UNITED STATES PATENT AND TRADEMARK OFFICE

APPLICATION NO.	FILING DATE	FIRST NAMED INVENTOR	ATTORNEY DOCKET NO.	CONFIRMATION NO.
10/710,843	08/06/2004	Hung-Cheng Lin	13063-US-PA	4842

Office Action Summary	Application No.		Applicant(s)	
	10/710,843		LIN ET AL.	
	Examiner		Art Unit	
	Jae Lee		2823

DETAILED ACTION

FIG 1B

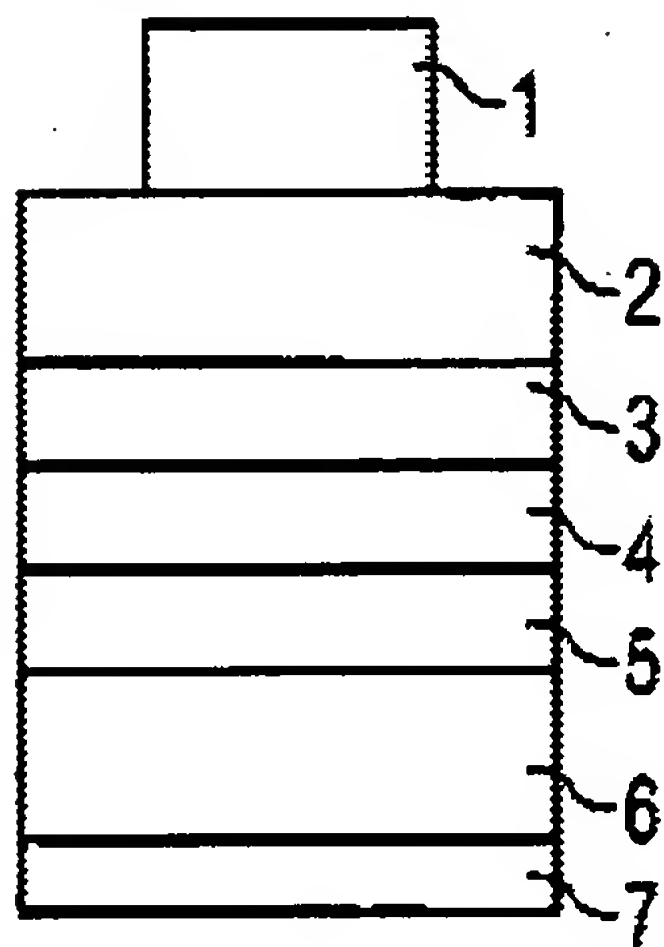
providing an epitaxial structure (see Fig. 1B, epitaxial structure **5,6,7**);

forming a third mask layer over the second mask layer to expose a portion of the second mask layer above the first mask layer (see Figs 1B, masking layer 1 exposing masking layer 2);

FIG 1C

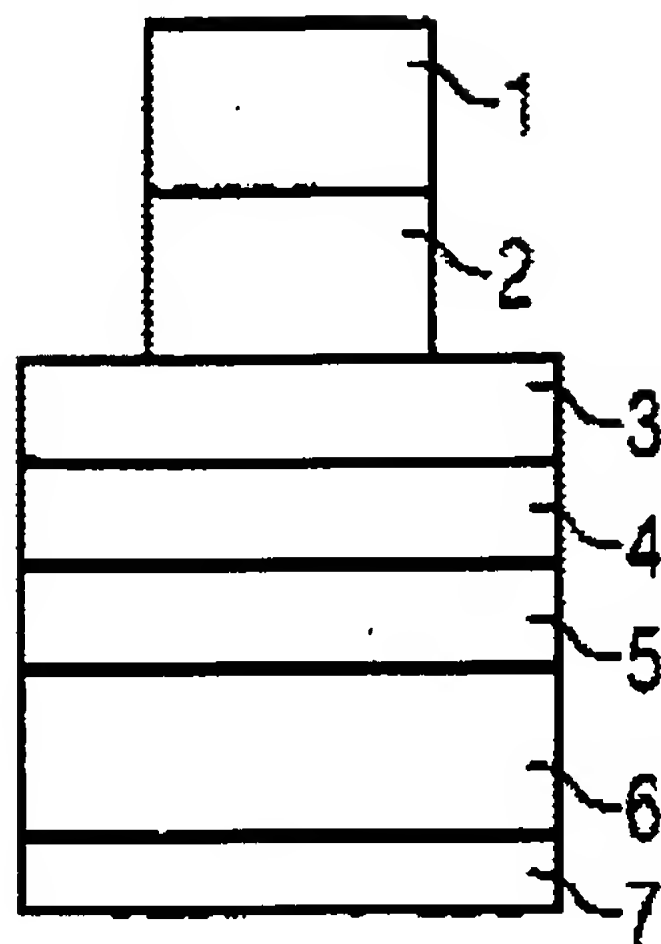
removing the exposed second mask layer (see Figs. 1C, exposed masking layer 2 removed);

FIG 1D

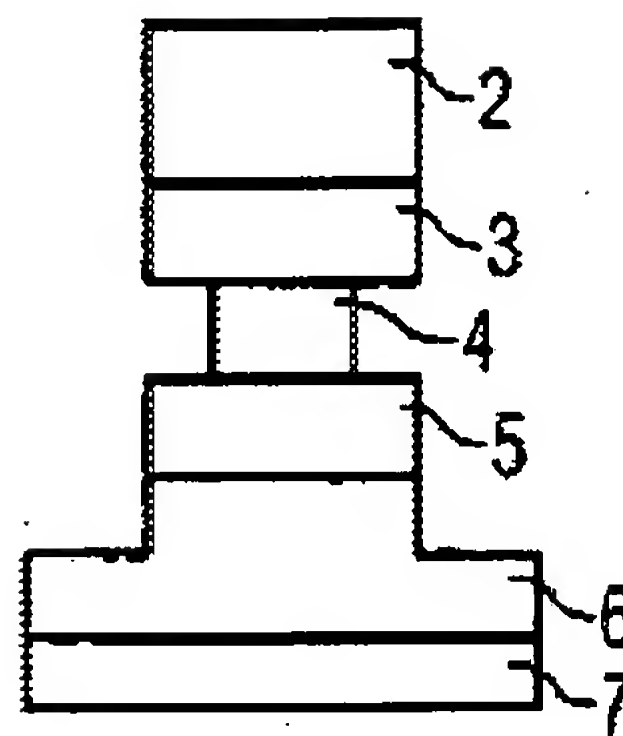
removing a portion of the epitaxial structure using the first mask layer and the third mask layer as an etching mask to form the ridge structure (see Fig. 1D, epitaxial structure 5,6,7 removed using Au sacrificial layer 4 and masking layer 2);

FIG 1E

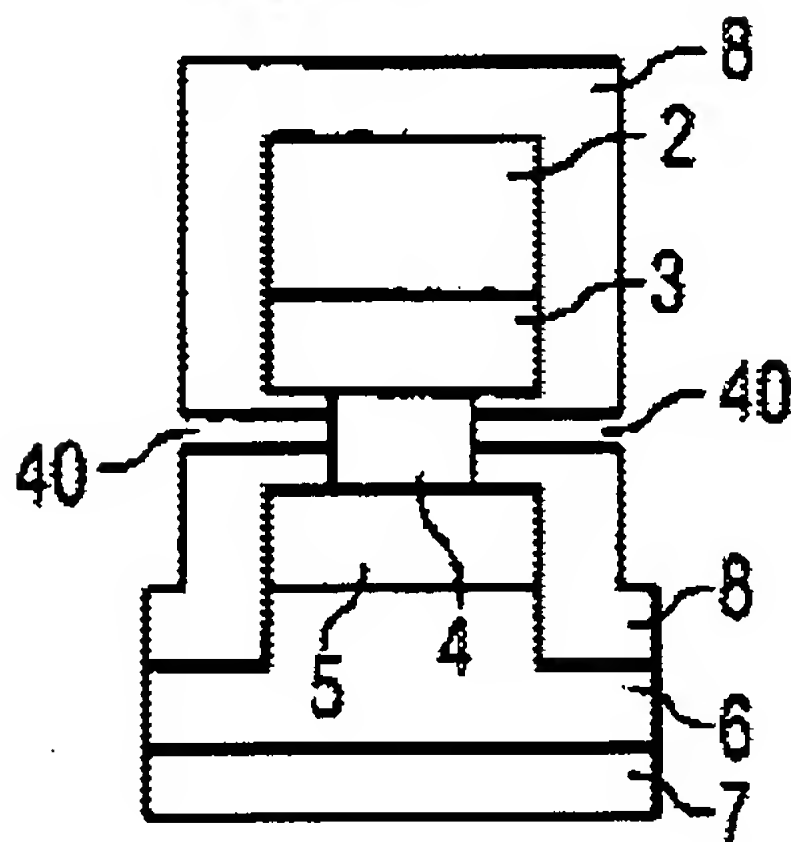
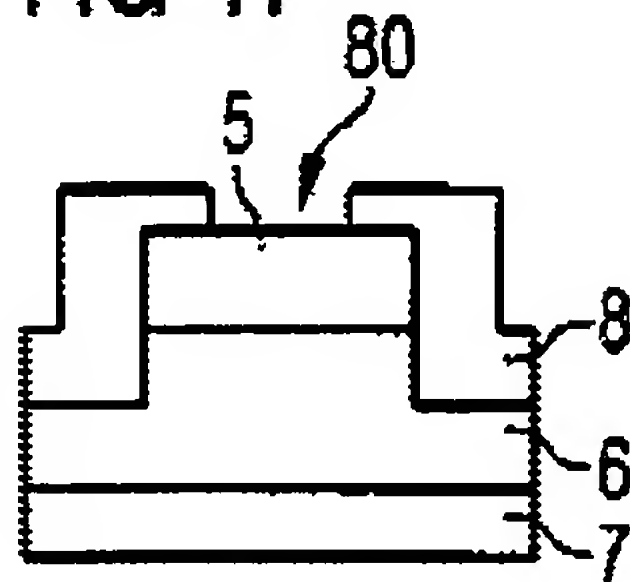
removing the third mask layer and the remaining second mask layer (see Fig. 1E-1F, Au sacrificial layer 4 and masking layer 2 removed);

forming an insulating layer over the epitaxial structure (see Fig. 1F, insulating layer 8);

removing the first mask layer to expose the top surface of the protrudent area (see Fig. 1E-1F, Au sacrificial layer 4 removed); and

FIG 1G

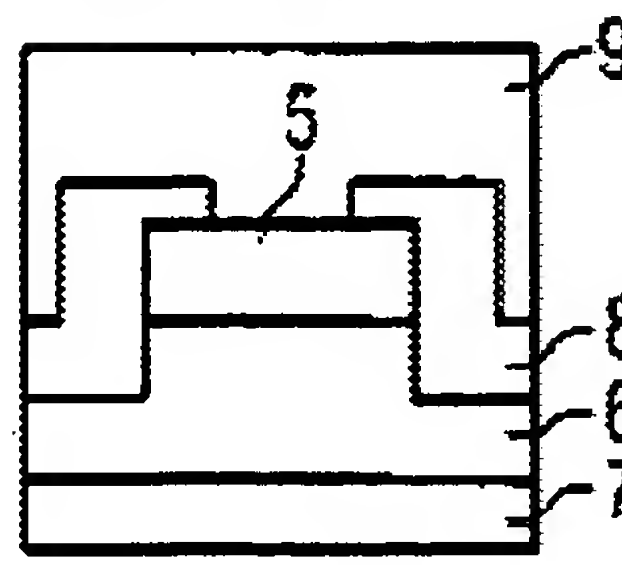
forming a conductive layer over the ridge structure, wherein the conductive layer contacts with the top surface of the protrudent area (see Fig. 1G, conductive layer 9).

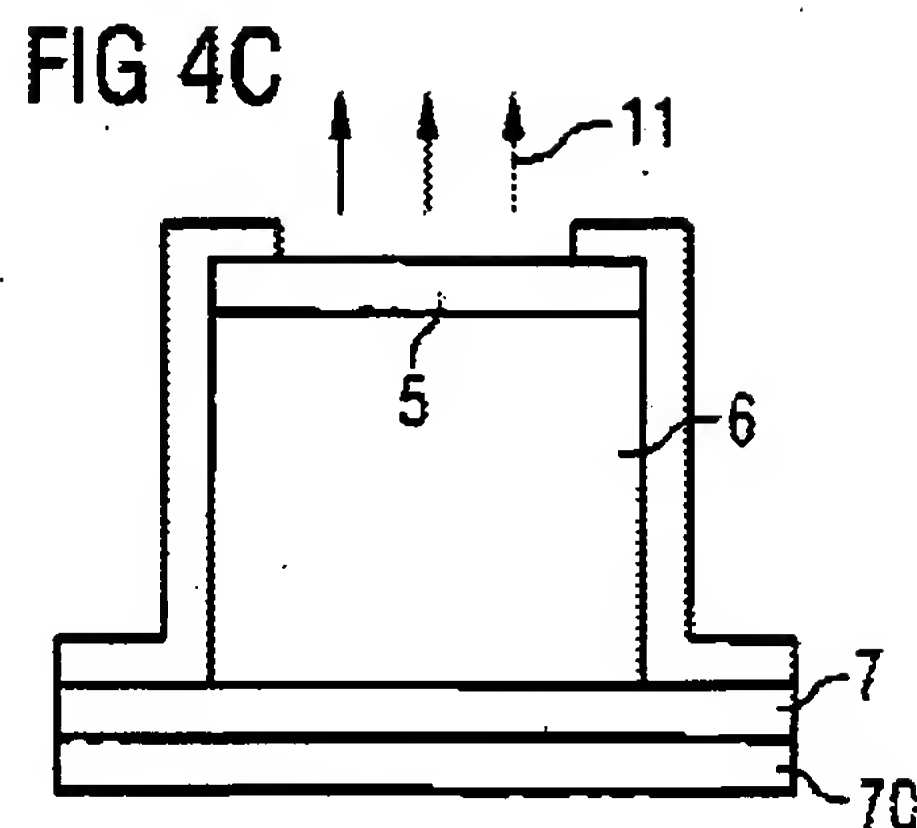
With regards to **claim 7**, Hoss et al. teaches the limitations of **claim 1** for the reasons above. Hoss et al. teaches a Pt P-type contact metal layer (see Fig. 4C, Pt- P-type contact metal layer **5**; ¶36, line 3)
